Rainbow SkyReach (Pty) Ltd

ALERT SERVICE BULLETIN

IMPORTANCE	High
AREA AFFECTED	Packed Parachute Assembly
SB NUMBER	CH/005/04-2018

Figure 1: (a) Egress panel cut out 1

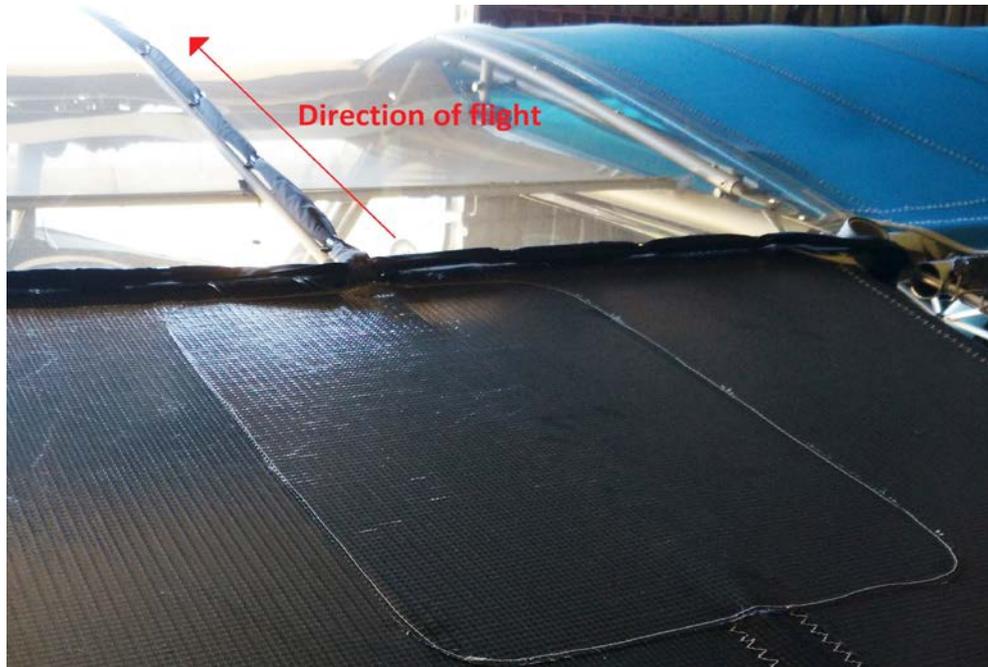
- Aircraft with Egress panel cut out 1 **and** BRS system installed (see figure 1(a)).
- All aircraft with Egress panel cut out 2 **or** no installed BRS system are not affected (see figure 1(b)).

Instead of being mounted perpendicular to the direction of flight, the parachute and tray installation needs to be rotated as a unit so that the rocket mounted to the right hand side of the tray aligns with the egress panel stitched into the fuselage sail.

Rotate the parachute assembly on the support strut by loosening the bolts on the mounting brackets, turning the assembly and retightening the bolts. It is imperative that after the rotation the rocket is positioned beneath the cut out in the trilam made to facilitate rocket penetration.

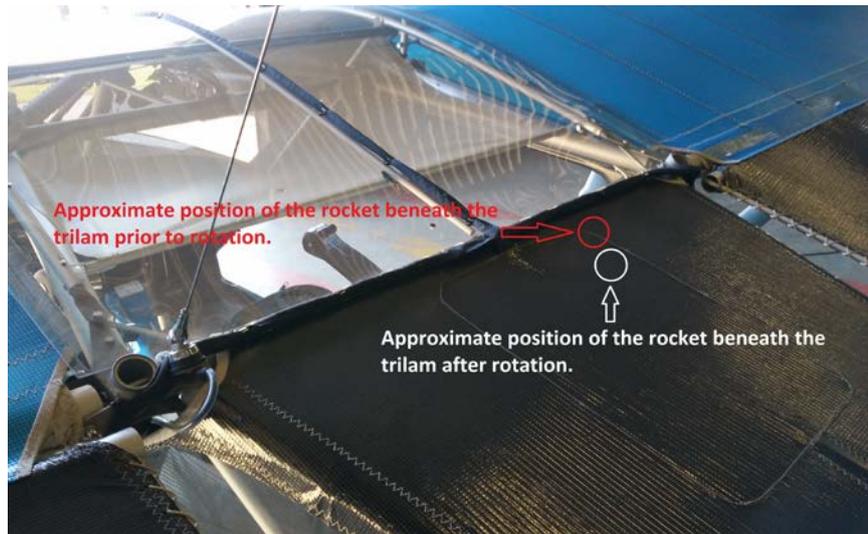
Press lightly on the trilam from the top while a second person supports the parachute assembly against the support strut to check that the rocket sits beneath the egress panel beneath the trilam as shown.

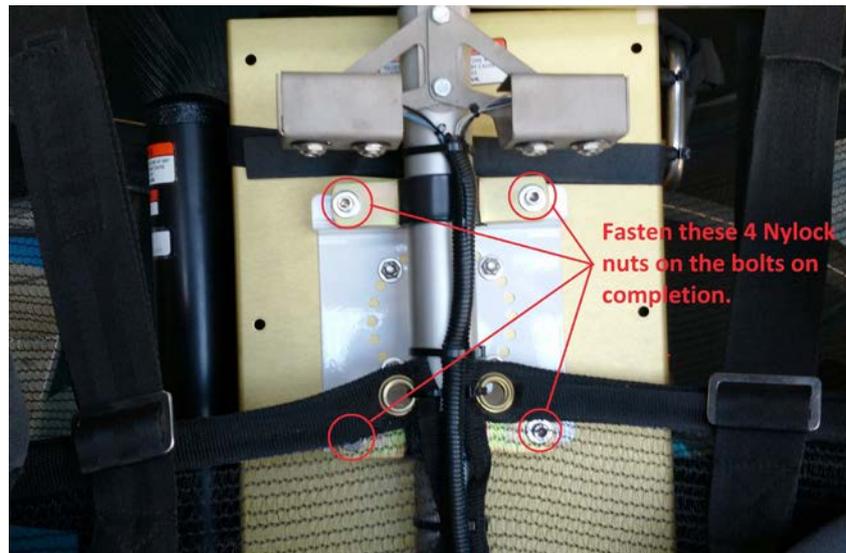
Tighten all 4 Nylock nuts on the 4 bolts on the mounting brackets to secure the parachute assembly back to the support strut in the new position.

It is once again advisable to have a second person supporting the parachute assembly while the first person tightens the nuts once more.
